25. DMR No. 95-DMR-ERM-0028

**DOCUMENT CLASSIFICATION  
REVIEW WAIVER PER  
CLASSIFICATION OFFICE**

2. or 3. Document Number/Revision RFP/ER-TM1-93-OU9.2/Rev. 0			5. Document Title EG&G RFP OU9 Technical Memorandum No. 1, Volume I, Part A	
8. Item	9. Page	10. Step	11. Proposed Modifications	
9	Sec.3	3.2.5	Replace page 18 to make 3.2.5 flow from 3.2.4 to 3.2.6.	
10	Sec.3	Pg.19	Replace Figure 3-4	
11	Sec.3	3.2.6	Replace entire section of 3.2.6	
12	Sec.3	Pg.20B	Add Figure 3-4a	
13	Sec.3	3.2.9	Replace first paragraph of section.	
14	Sec.3	3.2.11	Replace entire section of 3.2.11	
15	Sec.3	Pg.27A	Add Figure 3-6a	
16	Appen.A		Add pages A-5A, A-5B, replace pages A-6, A-7, add pages A-7A, A-7B, A-15A, A-15B, A-18 and A-19	
17	Sec.5		Replace Table 5-1	
18	Appen.D		Add page D-8, "Tank T-8"	
12. Justification (Reason for Modification)

FIGURE 3-4a  
SAMPLE LOCATIONS  
FOR T-11 AND T-30  
Operable Unit 9  
Original Process Waste Lines

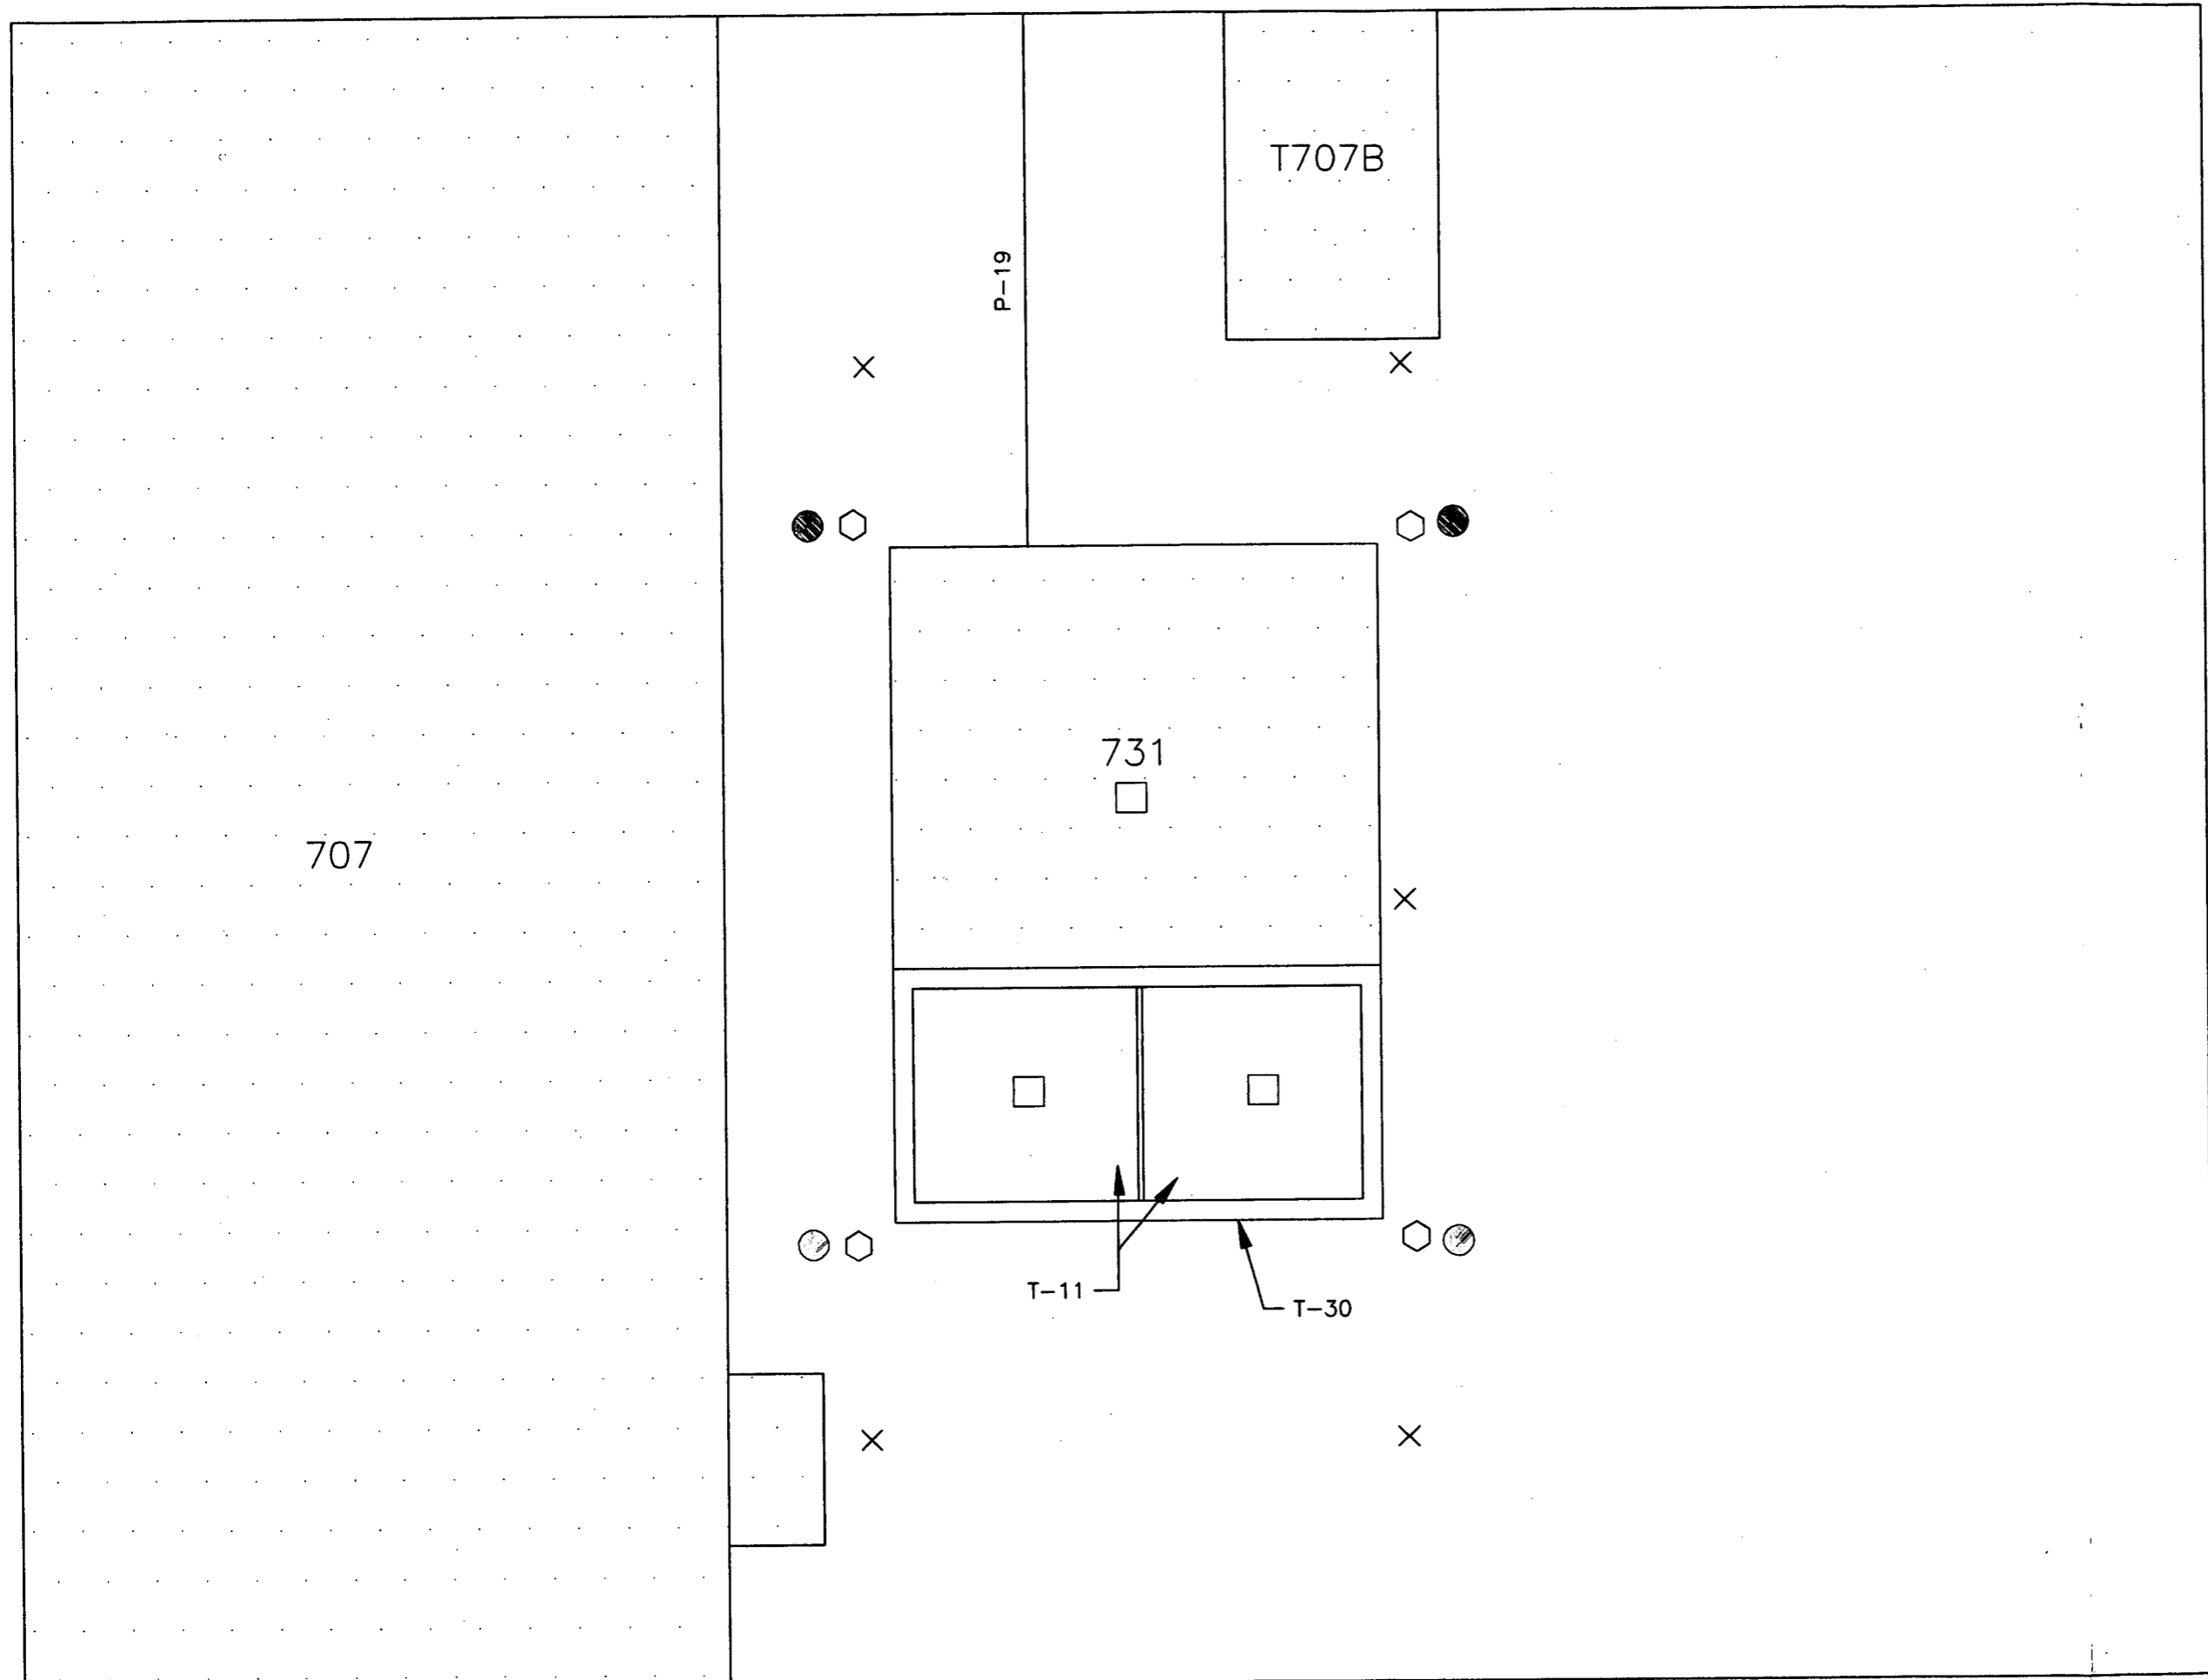
95-DNR-ER-M-0028  
If groundwater is encountered in the boreholes, a HydroPunch® sampler or equivalent will be used to collect a groundwater sample. One residue sample will be collected from each tank. If no residue is present, then 1 wipe sample will be taken from the vault area for radiological analysis. Sample locations are provided in Figure 3-4a.

FIGURE 3-6a  
SAMPLE LOCATIONS  
FOR T-24 and T-32  
Operable Unit 9  
Original Process Waste Lines

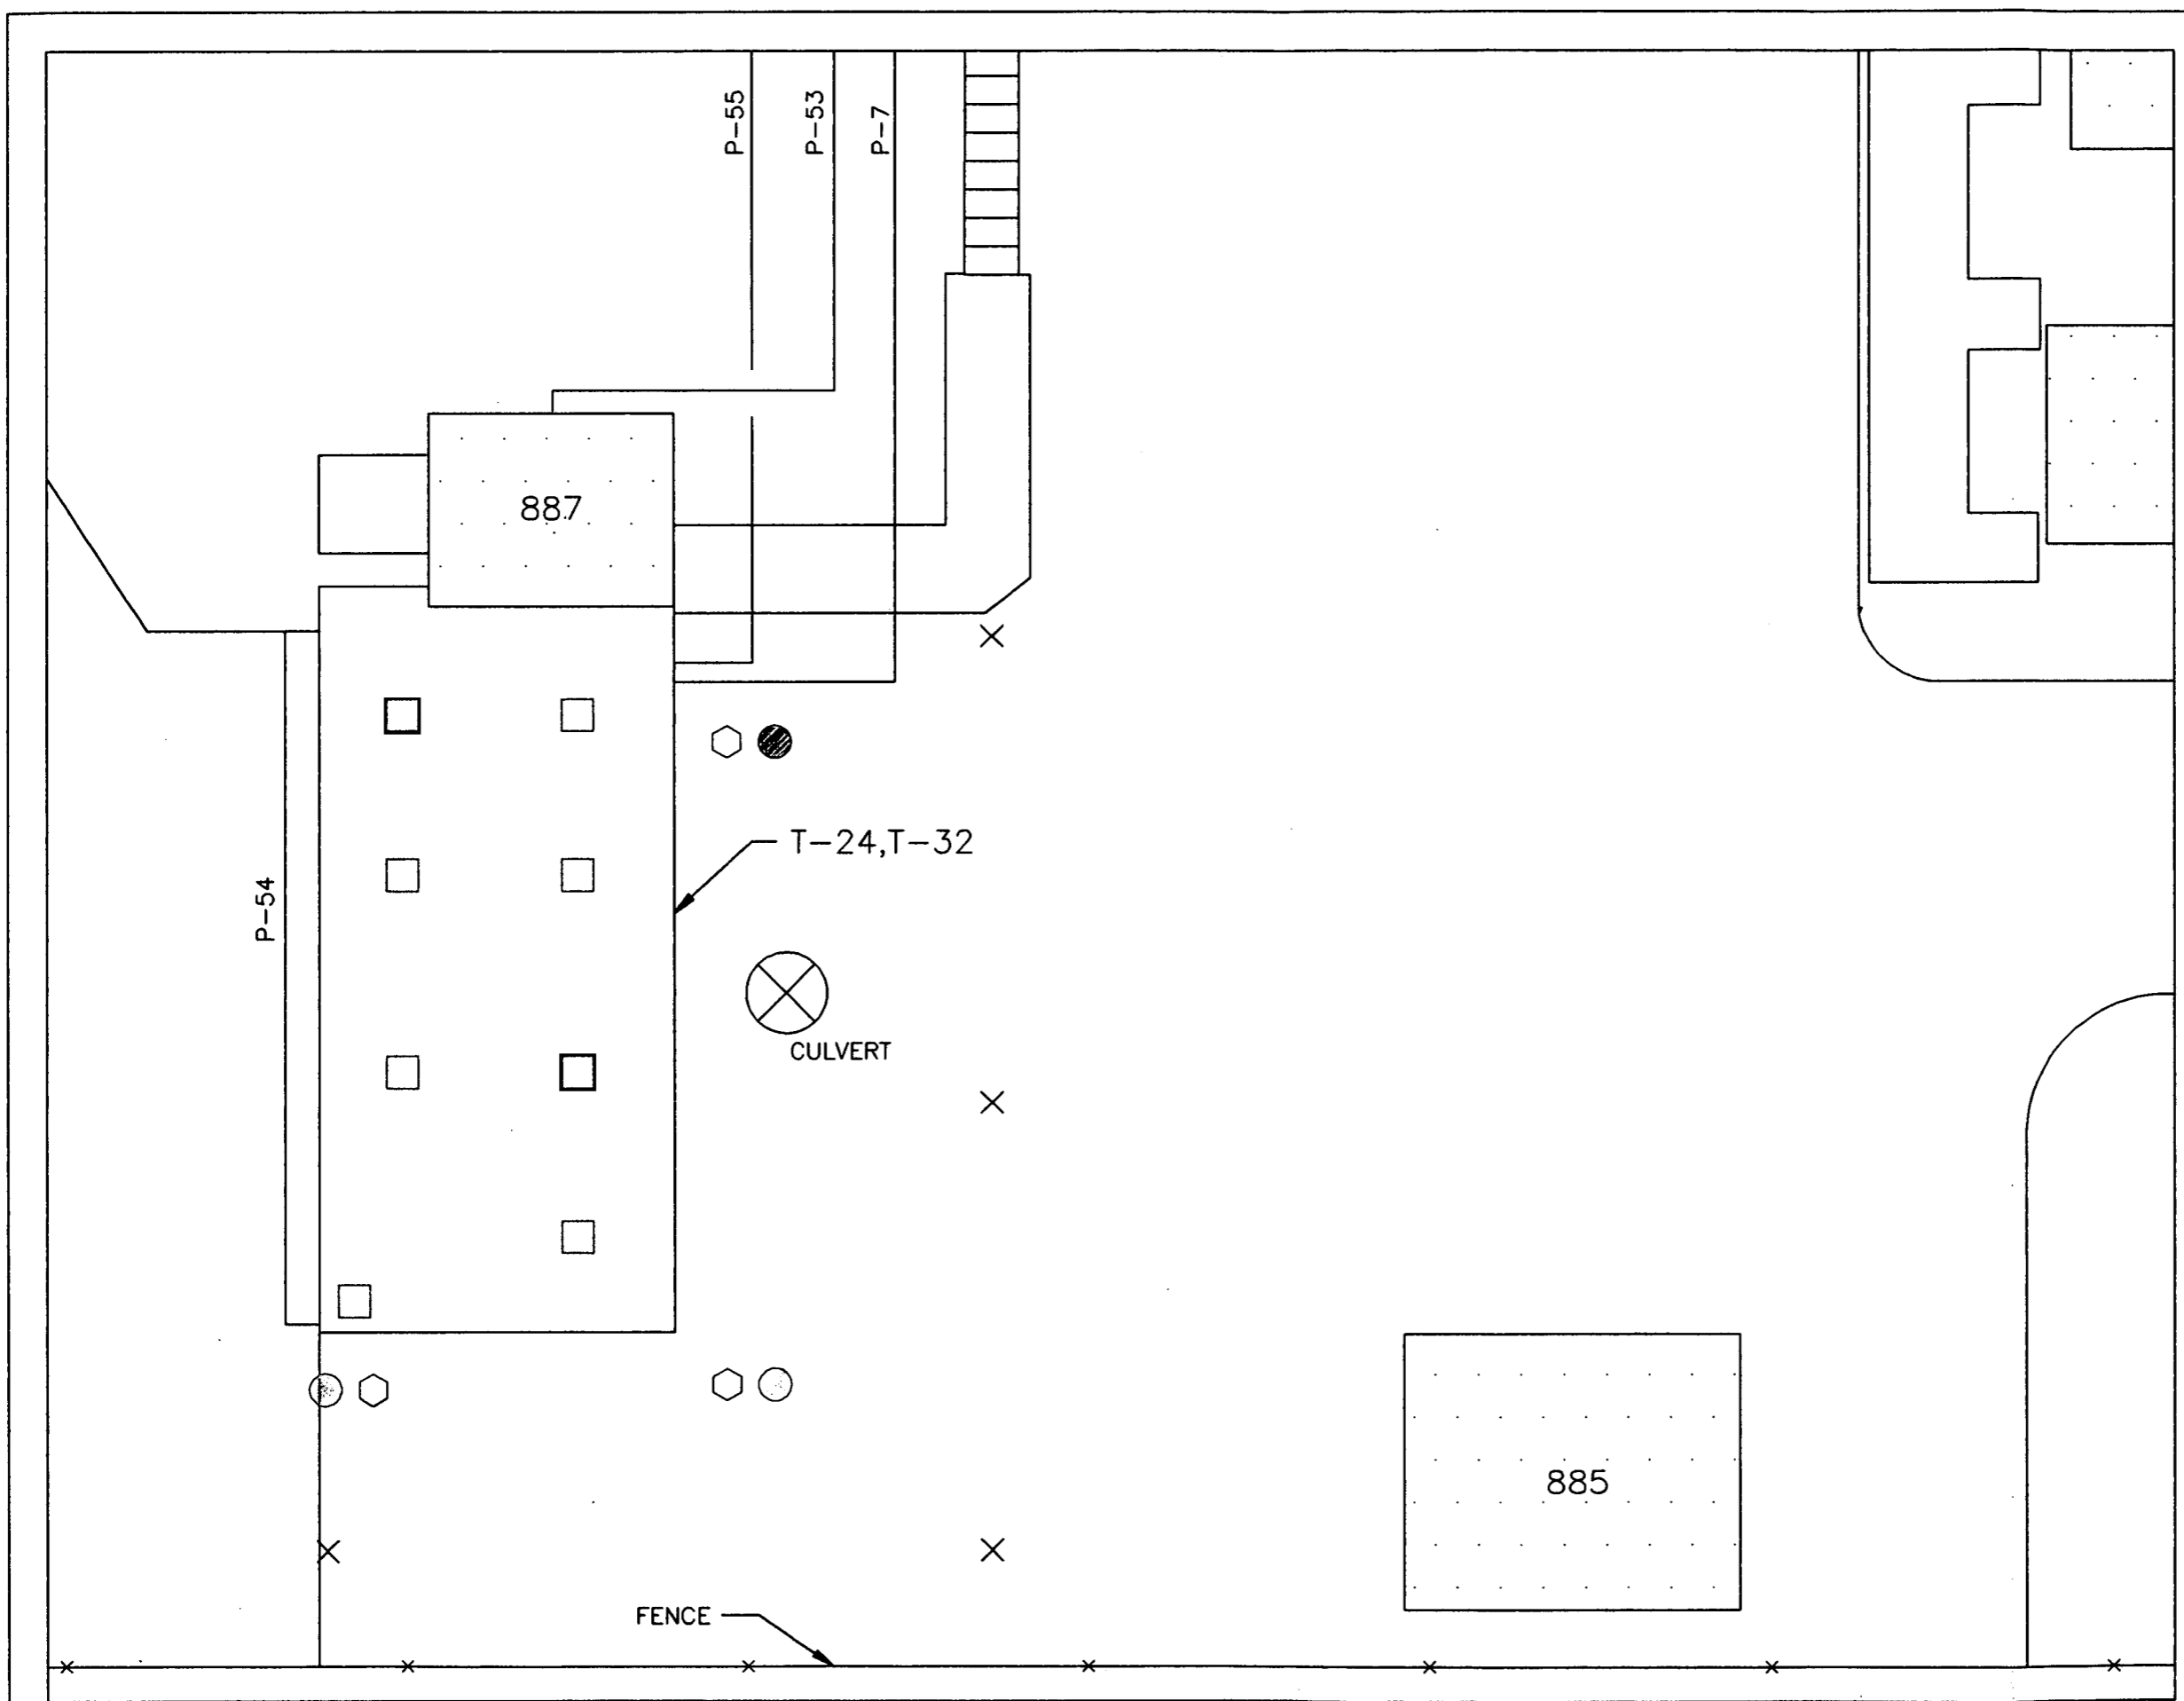
95-TANK-REM-0005  
A total of three soil boreholes will be drilled down-gradient of the tank location. Due to an active process waste line located to the west of the tanks and the concrete vault to the north, a fourth borehole can not be drilled as these areas are not accessible. Three soil samples from each borehole will be collected at the following locations: ground surface before drilling (0 to 6 inches), 1 foot below the base of the tank (estimated at 18 to 21 feet below ground surface), and directly above the water table (estimated at 22 to 25 feet below ground surface). If groundwater is encountered in the boreholes, a HydroPunch® sampler or equivalent will be used to collect a groundwater sample. Sample locations are provided in Figure 3-6a.
